SUBMITTAL SUMMARY REPORT MajorSite-000493-2026

PLAN NAME: Church Entry/walkway	LOCATION: 10050 S US HWY 441 BELLEVIEW,
APPLICATION DATE: 03/11/2026	PARCEL: 37229-000-00
DESCRIPTION: New covered walkway structure at the Church.

Plan in Review – Waiver Request
Reference: Division 21 Sec. 2.21.1
(Major Site Plans)
Requested Classification: Minor Site
Plan (Division 20 Sec. 2.20.1)

LOCATION & SITE PLAN
THE CHURCH ON THE HILL

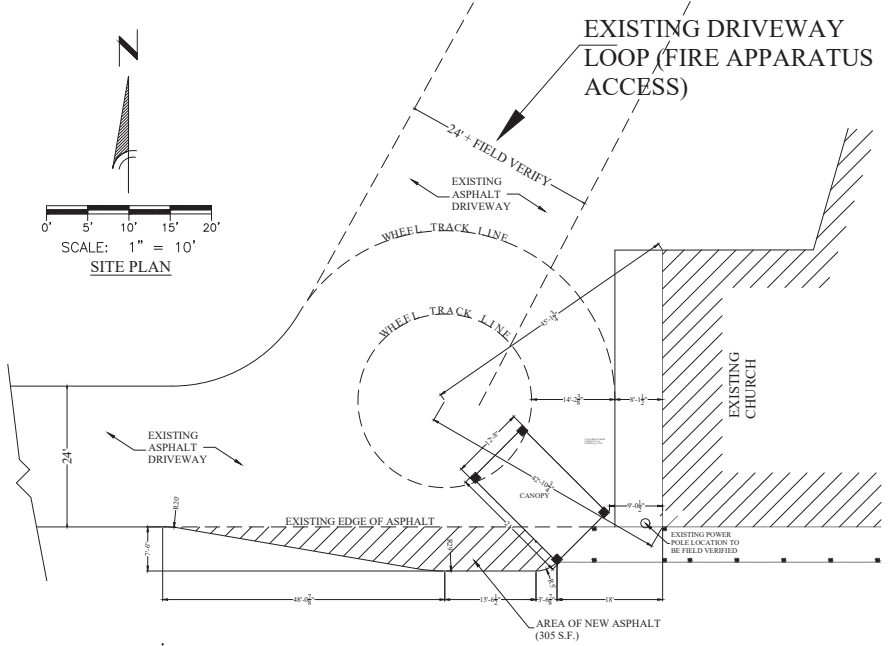
- Corrections** 2.12/4.2 - Building height (Not Resolved) - Please indicate required/proposed building height
- Corrections** 2.12 - Zoning Classification-adjacent properties (Not Resolved) - Please submit site plan indicating adjacent properties and respective zoning classification/FLU designations.

- Corrections** 2.12/4.2 - Lot setback (Not Resolved) - Please indicate required/proposed setbacks on separate site data table and on site plan
- Corrections** 2.12.10 - Easement (Not Resolved) - If applicable, please indicate any easements on site plan.

- Corrections** 2.12 - Parcel number (Not Resolved) - Please indicate parcel number on cover sheet
- Corrections** 2.12.4/6.11.7 - Loading area (Not Resolved) - If applicable, please indicate loading areas on site plan

- Corrections** 3.2.3 - NON-RESIDENTIAL - Complies with FAR (Not Resolved) - Please indicate maximum/proposed allowable Floor Area Ratio (FAR).
- Corrections** 2.12.4.L & Article 5 - Overlay zones (Not Resolved) - Include following statements in cover sheet: (1) FEMA Flood Zone X, (2) No ESOZ, (3) Primary Springs Protection Zone

- Corrections** 2.12/2.12.21 - Open space and natural areas (Not Resolved) - Please indicate required/proposed open space
- Corrections** 2.12 - Waivers (Requested & Approved) (Not Resolved) - Are any waiver applications intended? In future submittals, please provide table of approved/proposed waivers/approval date/conditions

- Corrections** 2.12 - Site coverage (Not Resolved) - Please indicate existing/proposed impervious surface/building area in square footage, acreage, and percentage.
